**TOWN OF NEWBURGH
PLANNING BOARD
TECHNICAL REVIEW COMMENTS**

PROJECT NAME: ADS PROPERTIES CAR WASH
PROJECT NO.: 2021-04
PROJECT LOCATION: SECTION 95, BLOCK 1, LOT 14.1
REVIEW DATE: 9 JULY 2025
MEETING DATE: 17 JULY 2025
PROJECT REPRESENTATIVE: GNS GROUP

W.5

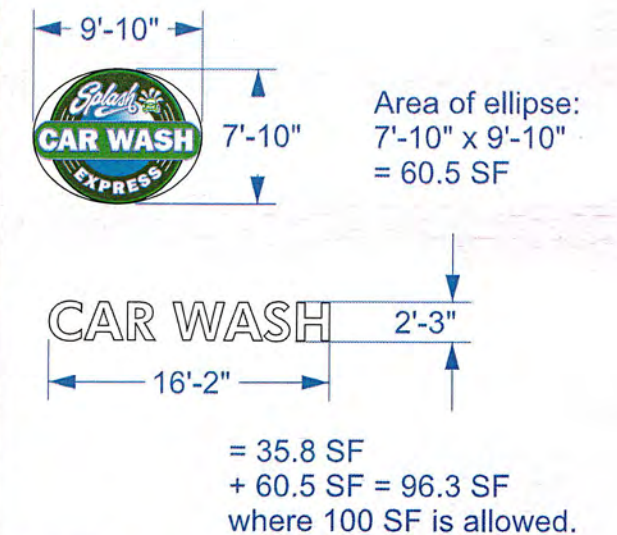
1. The project is before the Board for architectural review of the building façade. The signage is also depicted on the building.
